TRANSPORT & URBAN PLANNING PTY LTD

Re: Proposed QuarryWEST Masterplan
Response to Submission
Traffic Issues

I have reviewed the various submissions made concerning the QuarryWEST Masterplan proposal. This letter sets out a response to traffic issues raised in these submissions.

FIGURE 12 A

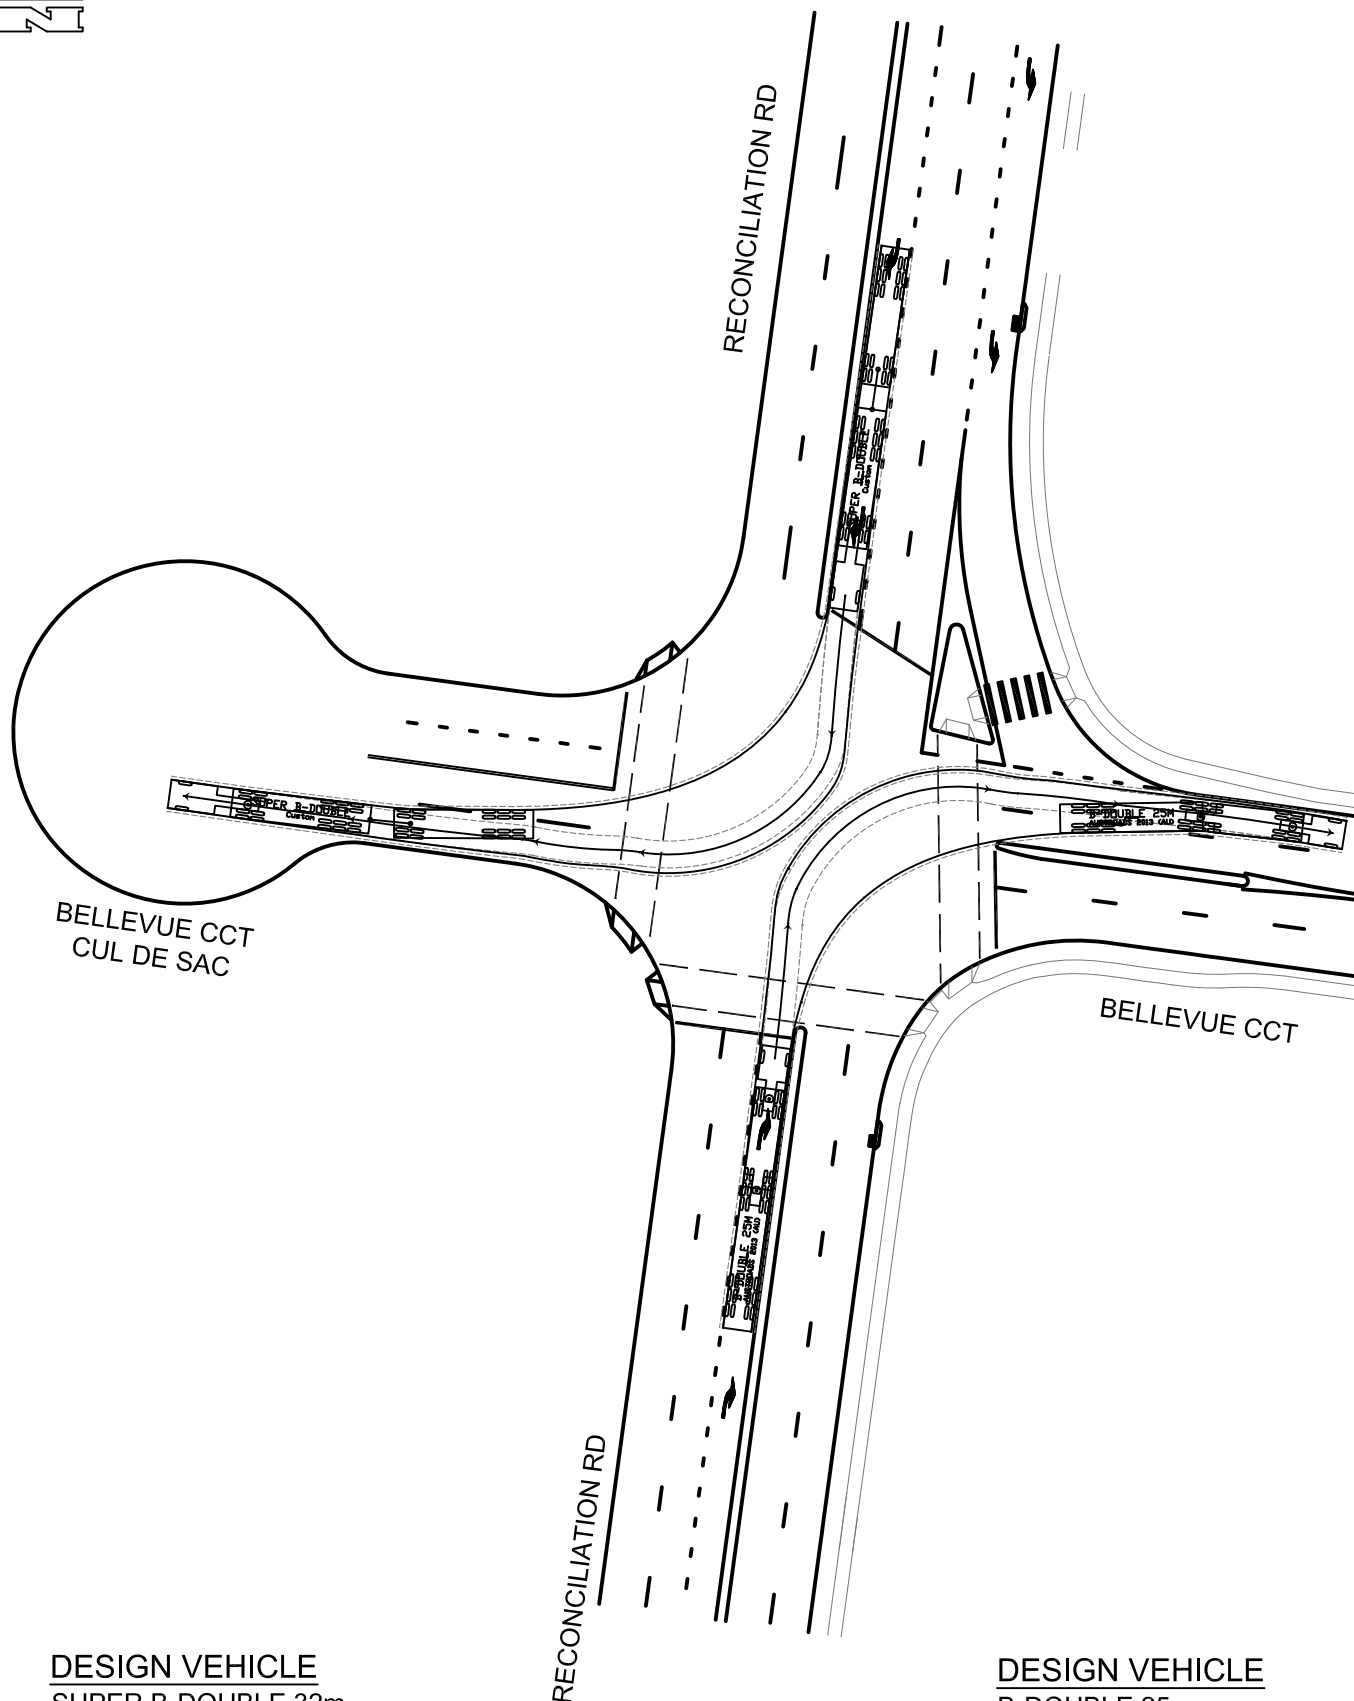
Issue 1. Design Heavy Vehicles. It would be prudent to adapt the turning path of a vehicle PBS Level 2B (i.e. up to 30 metres in length) to test the largest vehicle combination likely to access the development in the foreseeable future.

Transport and Urban Planning Pty Ltd has sourced details of a 32 metre long Super B Double and tested the swept path of this vehicle for the left and right turning movements into and out of the QuarryWEST Estate Roads at Prospect Highway (Reconciliation Road) (i.e. Bellevue Circuit Cul-De-Sac and Dolerite Close) and at the internal roundabout of Dolerite Close/Basalt Road.

The swept path diagrams are shown on **Figures 12A -12E**. Reference to these figures shows that these longer vehicles can negotiate these intersections in accordance with relevant Austroads requirements.
